LINCOLN PARK PLANNING COMMISSION

July 12, 2023 at 7 p.m.

AGENDA

Site Plan Review

CS.1	COVER SHEET
S1.0	SITE PLAN
S1.1	LANDSCAPING PLAN
A1.0	EXISTING & PROPOSED FLOOR PLANS
A1.1	MECHANICAL/REFLECTED CEILING PLAN
A2.0	DEMOLITION PLAN
A2.1	PROPOSED ELECTRIC PLAN
A2.2	PROPOSED PLUMBING PLAN
A3.0	EXISTING ELEVATIONS

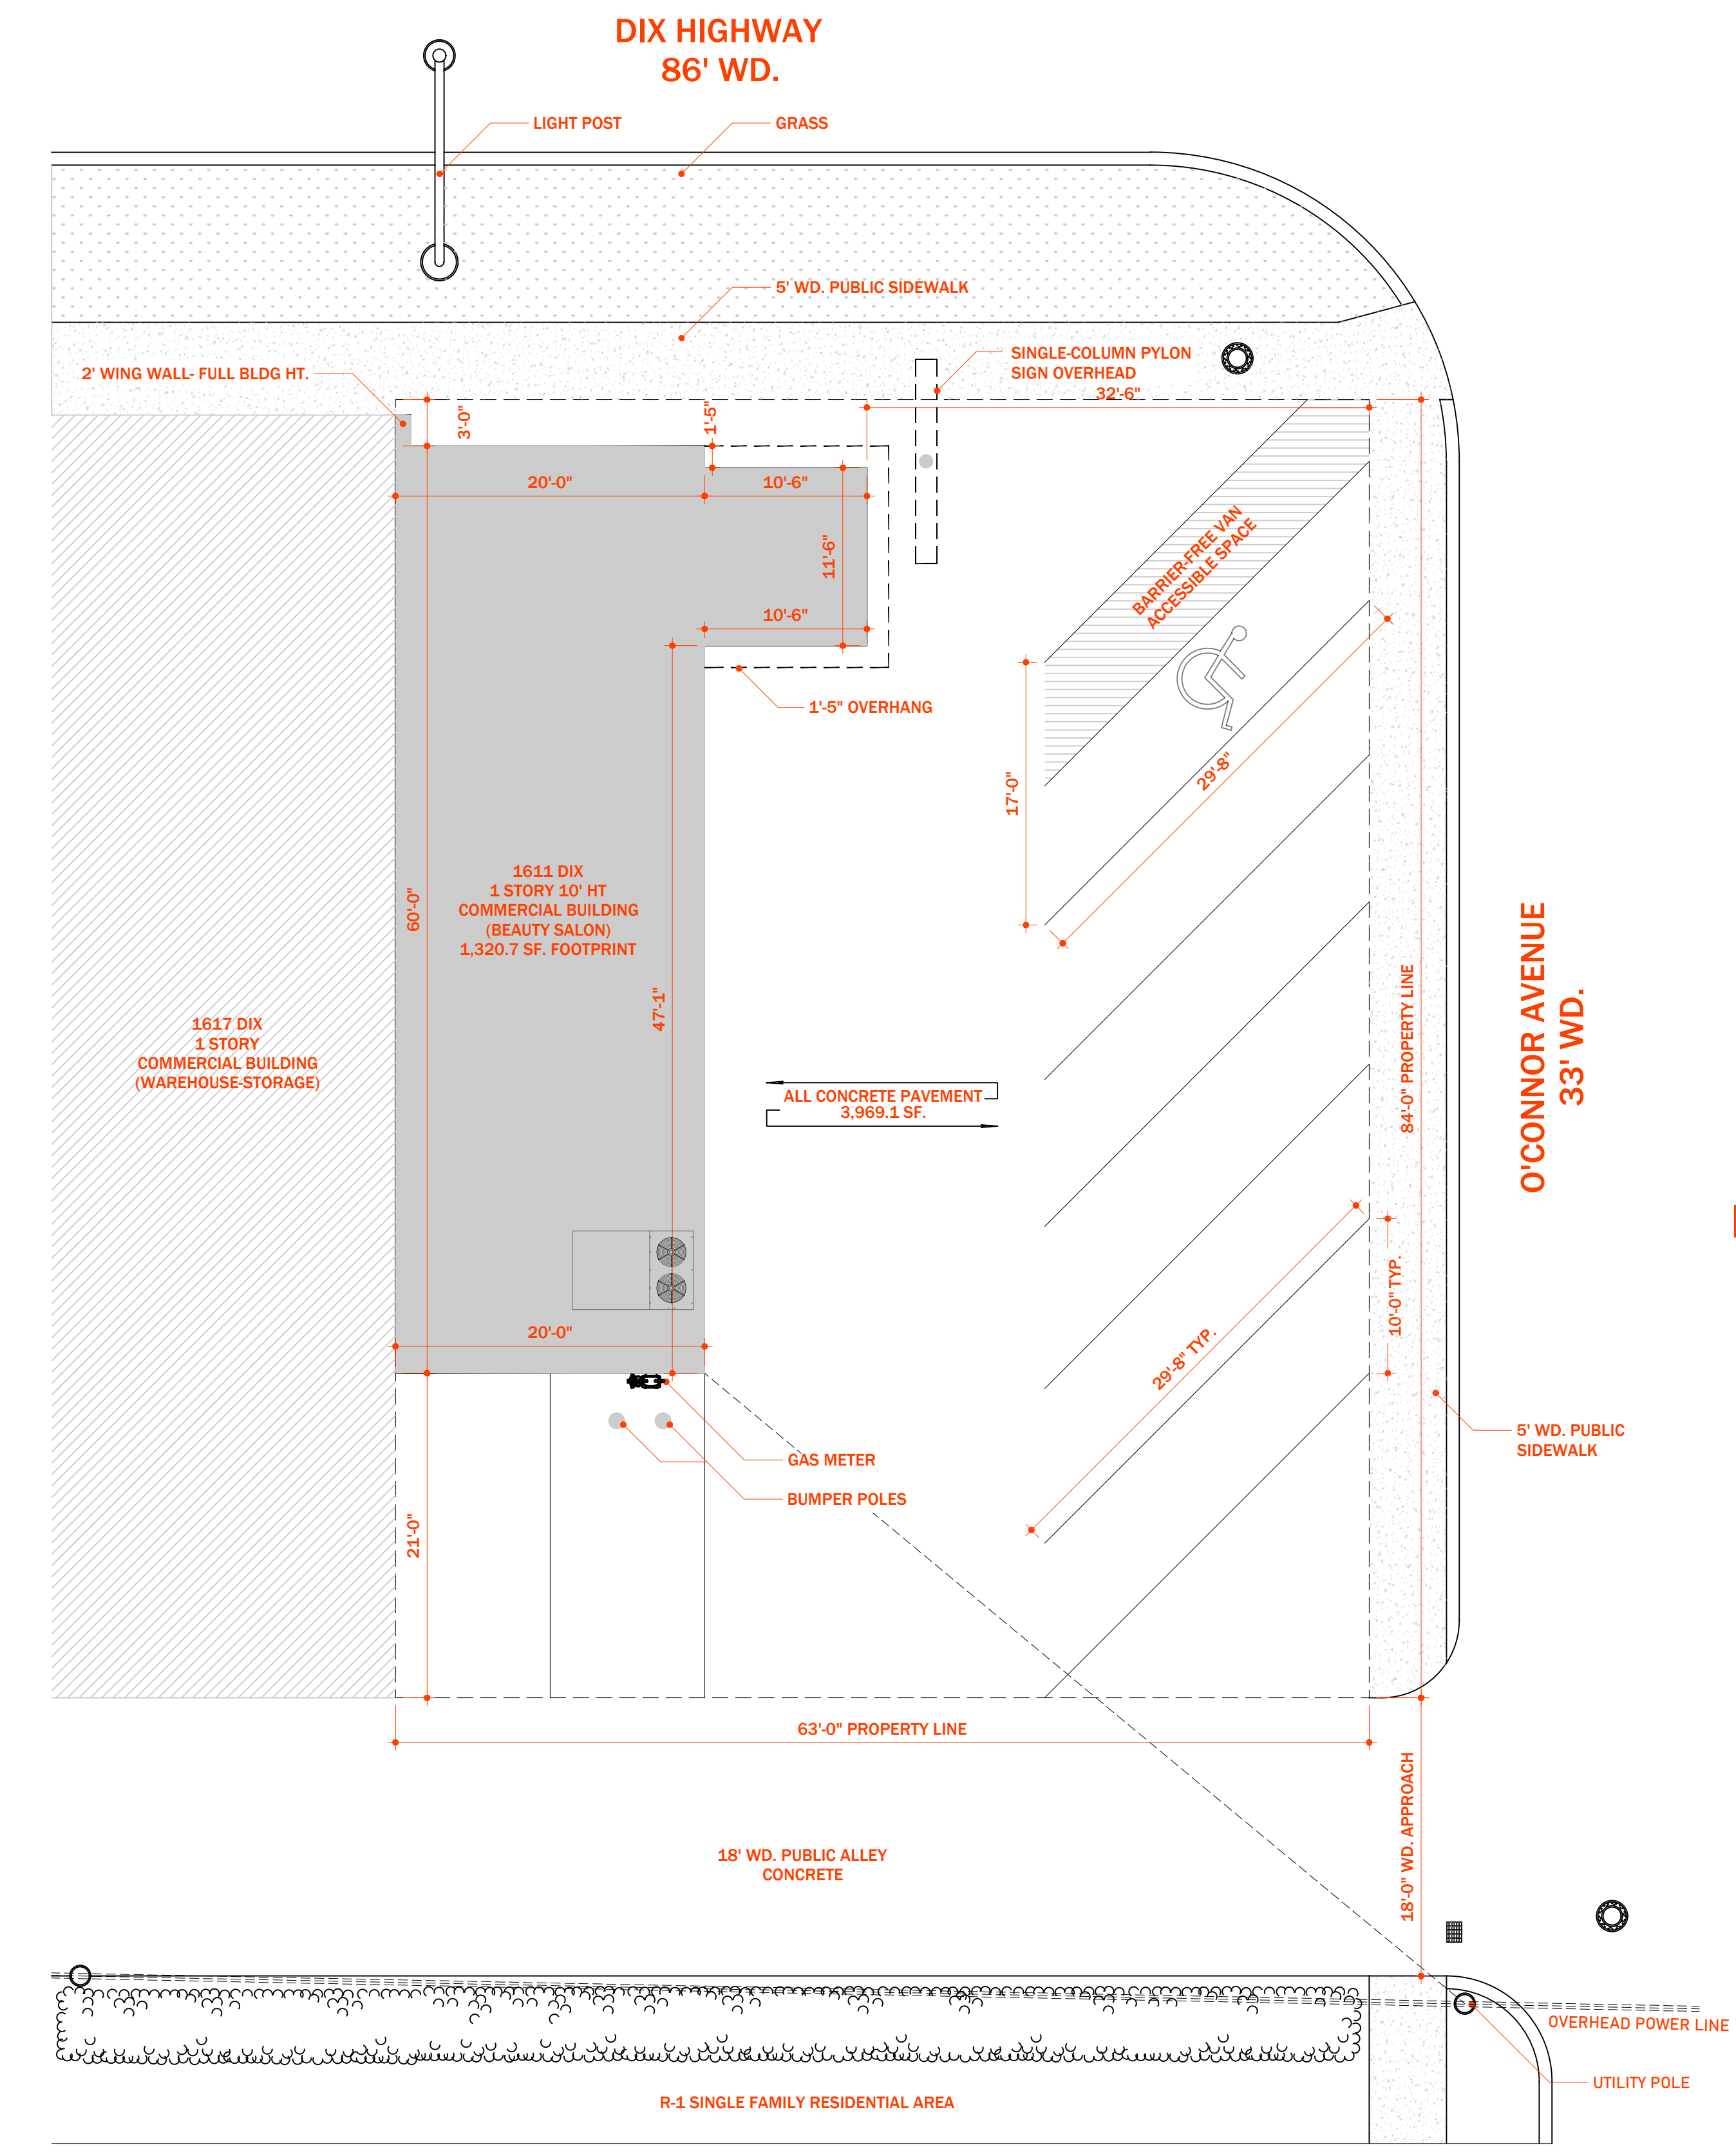
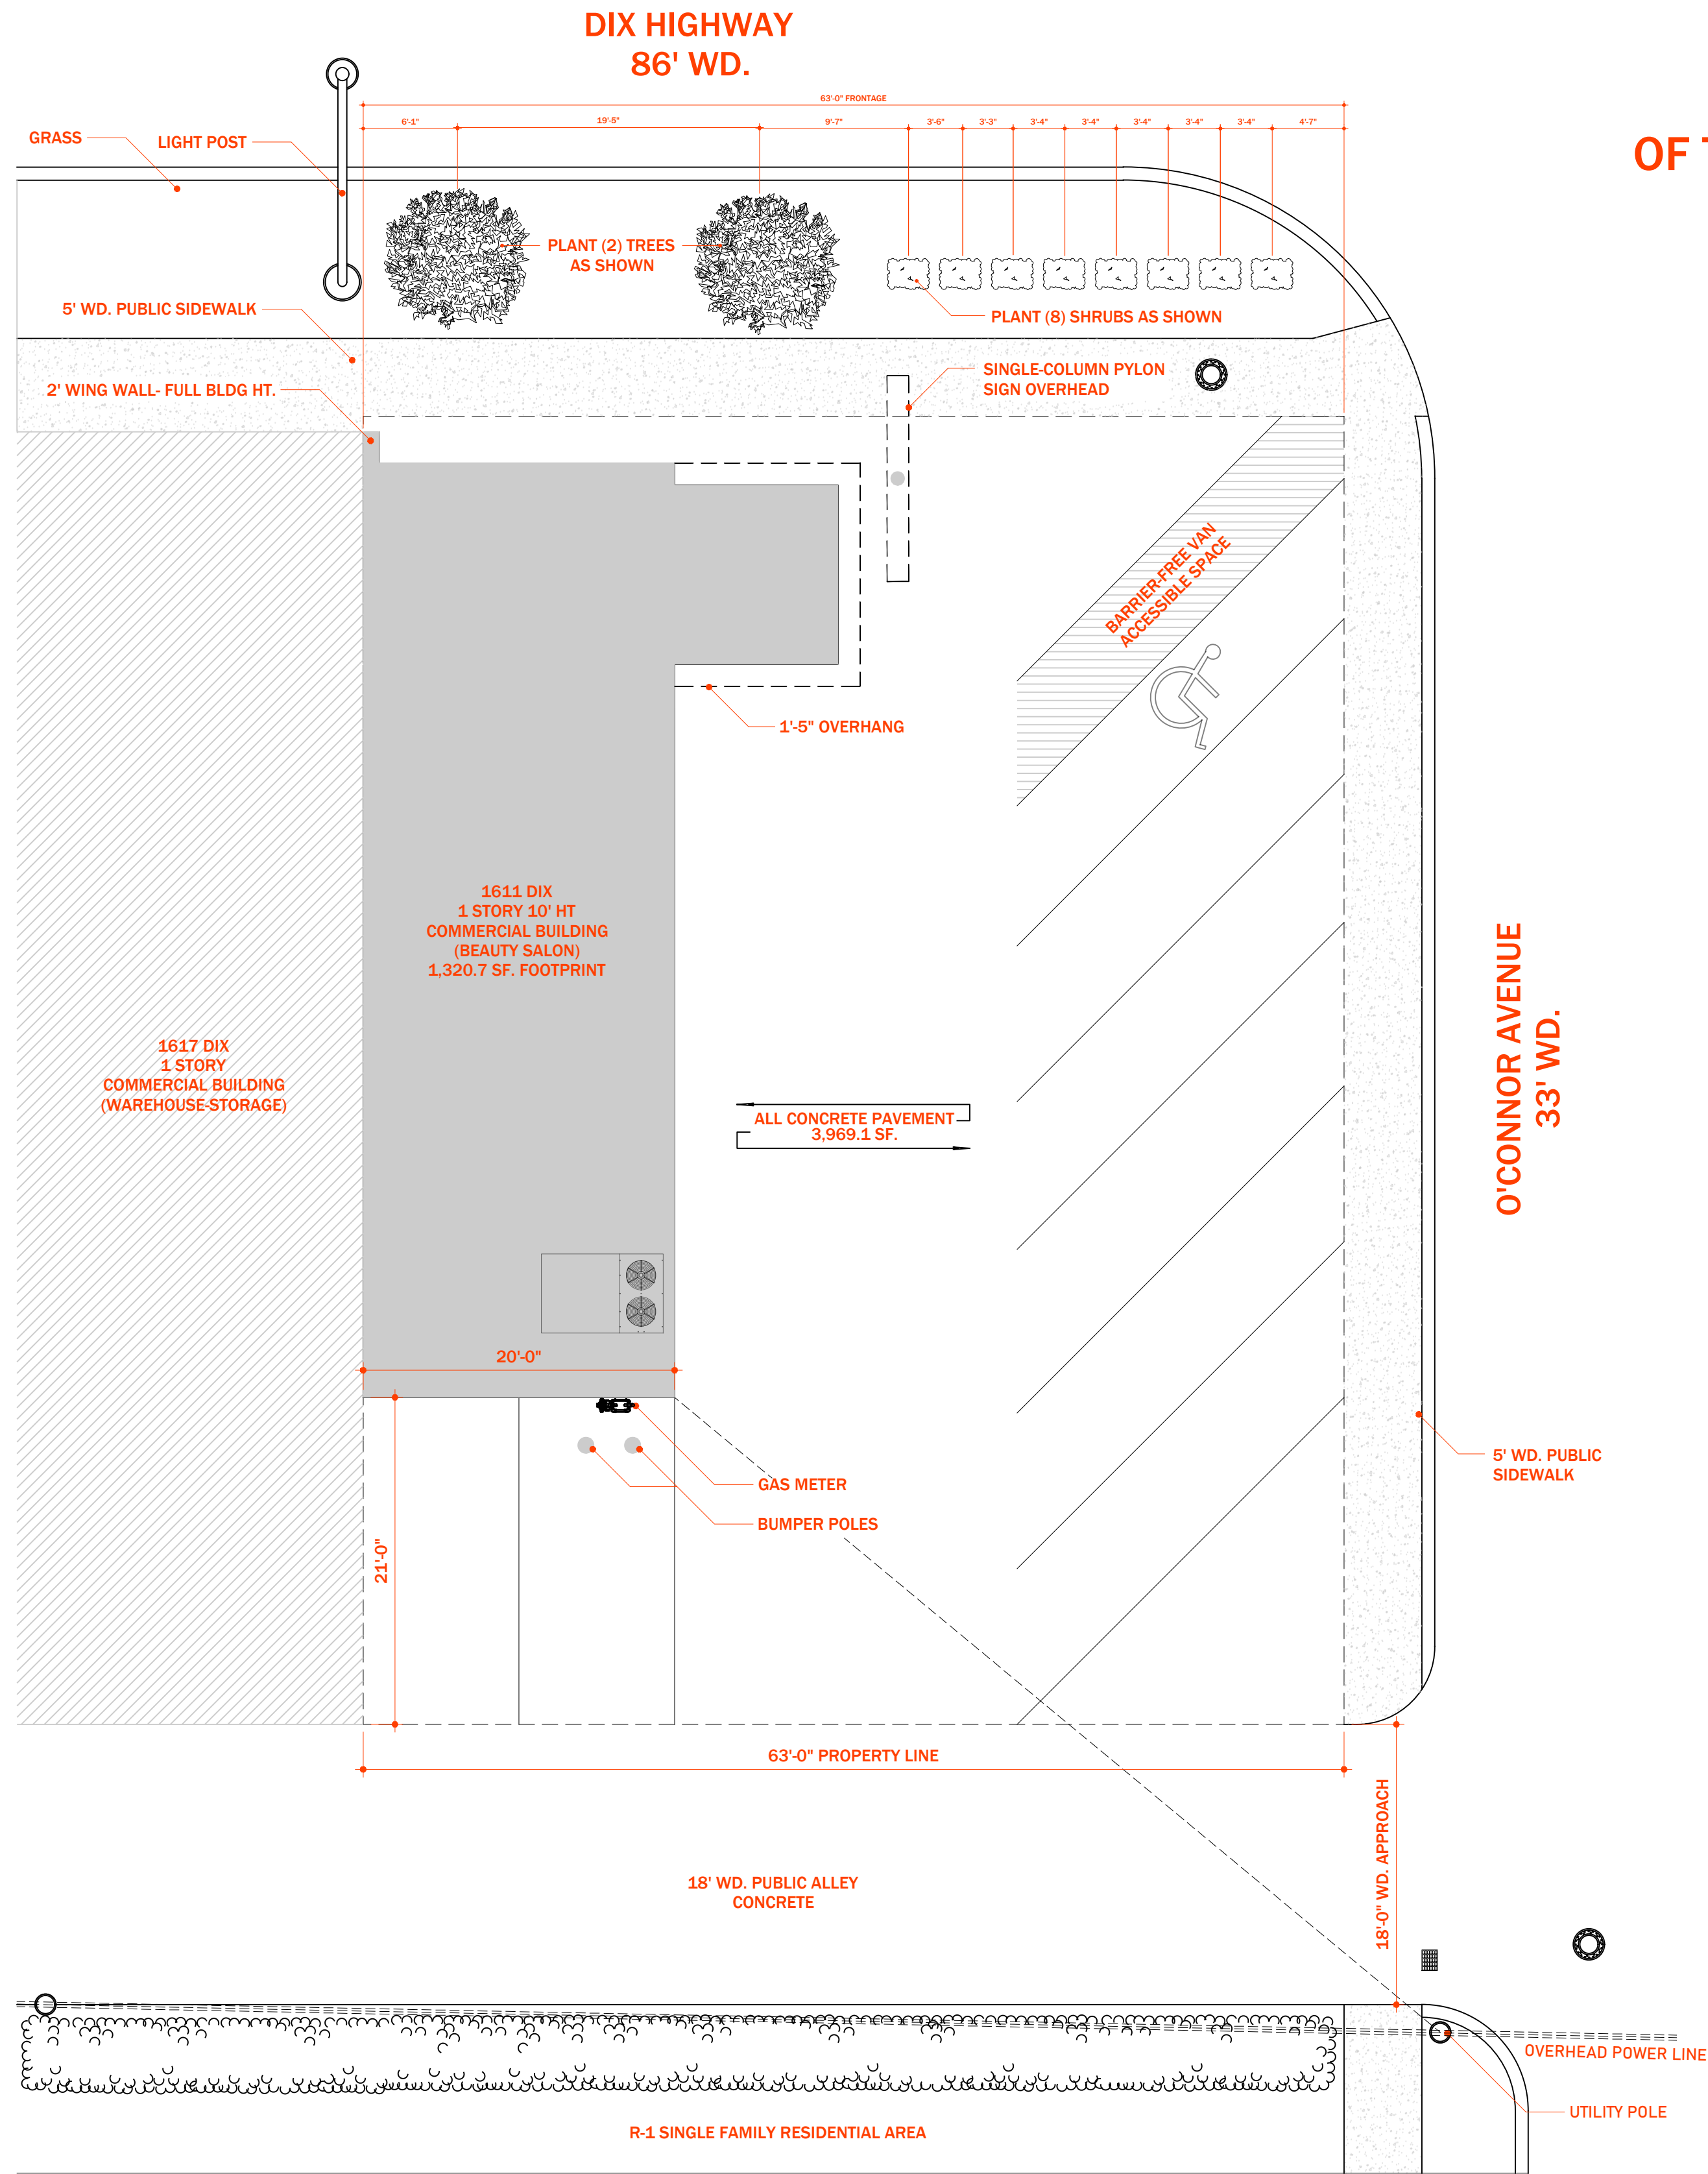
Required	Proposed	Compliance
Parking Area Type B §1290.05	Adequate means of ingress and egress shall be provided and shown	Existing ingress and egress via rear alleyway. However, parking spaces are diagonal which may lead to limited ability to maneuver within the lot to exit via rear alleyway.	INQUIRY
	Parking facilities, access drives, and maneuvering aisles shall be hard surfaced with concrete or plant-mixed bituminous material, maintained in a usable dustproof condition and graded and drained appropriately	Parking area has existing concrete. Engineering comments indicate required revisions to site plan notes on sheet S1.0.	INQUIRY
	Concrete curbs and gutters	Existing concrete curbs and gutters	Met

When adjoining residential property and/or a residential street or alley: 6' solid masonry wall, ornamental on both sides, with bumper guards	There are residential properties across the alley; however, there is no space on the site to provide a wall.	N/A
	All street boundaries of such parking facilities, where residential property is located on the opposite side of the street, shall be treated the same as set forth in Section 1290.04, Off-Street Parking A Areas; Residential Districts Adjoining Business or Industrial Districts.	There are residential properties across the alley; however, there is no space on the site to provide a wall.	N/A
	Entrance only from the adjoining principal use or adjoining alley; no use of street for backing or maneuvering	It is possible that with the current parking configuration, vehicles may need to use the alley for maneuvering.	INQUIRY
	In all cases where such parking facilities abut public sidewalks, a wall or curb at least six (6) inches high, or steel posts twenty-four (24) to thirty (30) inches high and not more than five (5) feet apart, set three (3) feet in concrete, shall be placed thereon so that a motor vehicle cannot be driven or parked with any part thereof extending within two (2) feet of a public sidewalk.	No barrier at the edge of any parking spots.	NOT MET

Ingress and egress to the site rely completely the public alleyway behind the site which may pose challenges to incoming/outgoing vehicles as the direction of movement in the alleyway is not marked. Further, the diagonal direction of parking spots on the site presents additional complications to maneuvering in order to reach the site's only exit via alleyway. Engineering comments indicate that the site plan notes on sheet S1.0 shall be revised to include the City of Lincoln Park standards for note #1, an 8-inch-thick drive approach for note #2, and a 4-inch-thick sidewalk for note #3.

- Applicant shall provide parking barriers between the parking spaces and the public sidewalk.
- Applicant comment requested as to how parking lot circulation will function.
- Applicant shall revise the site plan notes on sheet S1.0 to address Engineering comments.
